CLIENT DOCUMENT/DRAWING NO.:	0775-ENV-GEN-90-008	REV:	02
VALMEC DOCUMENT NO.:	4017-PLA-HS-013	REV:	2
SUBCONTRACTOR DOCUMENT NO.:		REV:	
DOCUMENT/DRAWING TITLE:	BROKEN HILL BESS PROJECT HIGH VOLTAGE POWER EASEMENT HERITAGE MANAGEMENT PLAN

PROJECT NO AND TITLE:	4017-BROKEN HILL BATTERY ENERGY STORAGE SYSTEM
CLIENT AND CONTRACT/PO NO.:	AGL ENERGY – 97712982

Broken Hill BESS: High Voltage Power Easement (Stage 2) Heritage Management Plan

Appendix 3: Cultural Heritage Constraints (AECOM 2022)

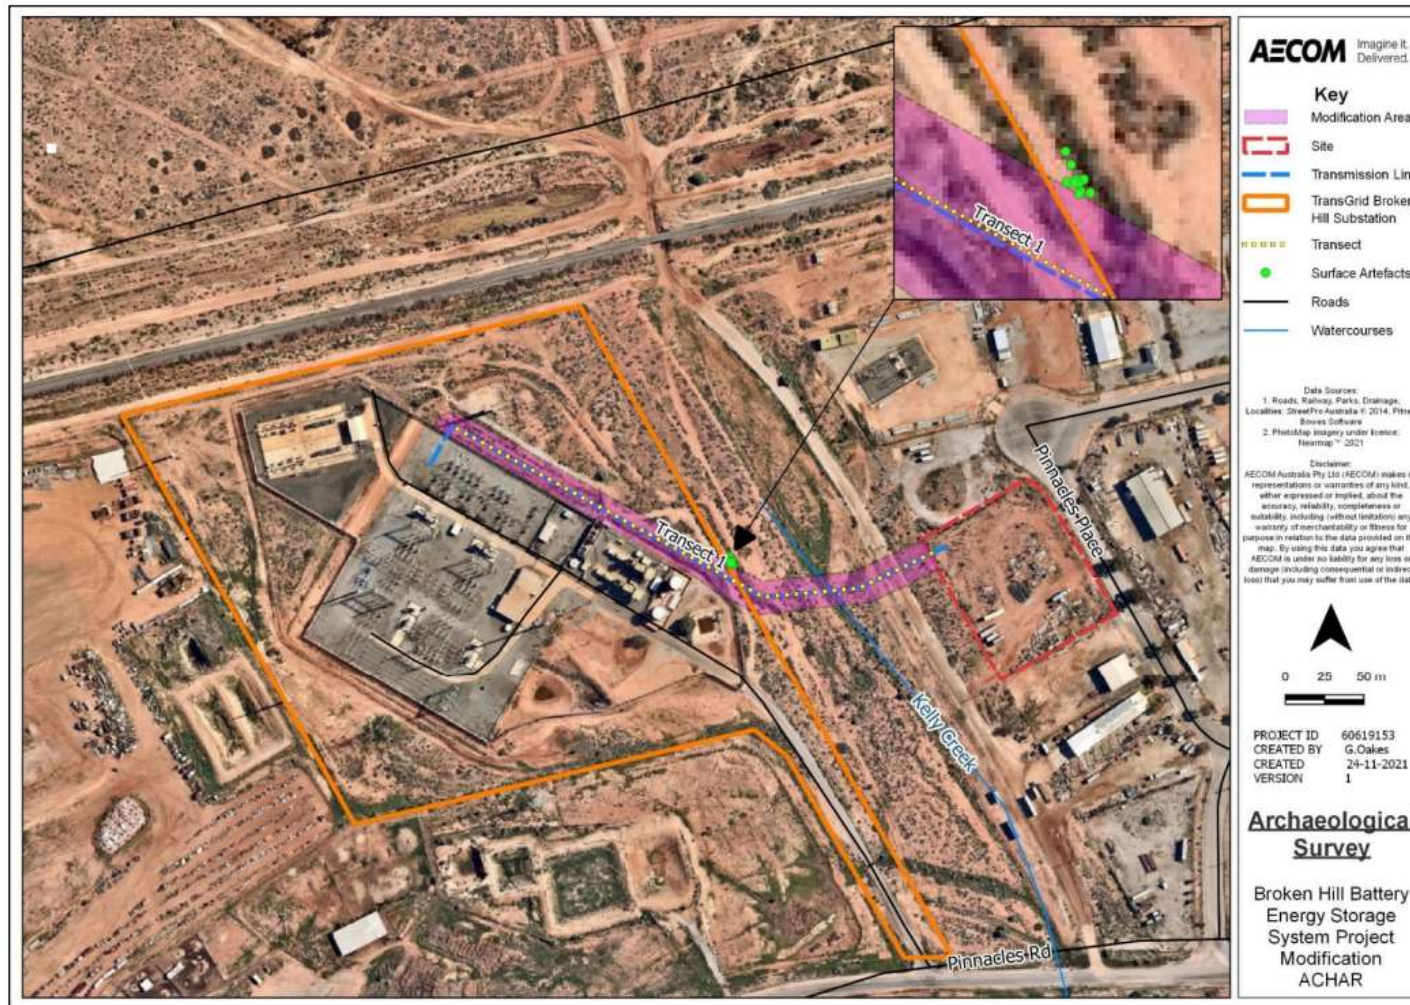
1. 2.2 Plan Development – 4 RAPs but consultation with 3 only (Cally Doyle not included) ?
2. 2.3.2 High Voltage Power Easement – Avoidance, no specific mgt measures provided in AHMP. Please ensure site is mapped in CEMP (or similar), exclusion fencing (if appropriate with RAPs) and included in inductions (& tool box meetings) as an exclusion zone.
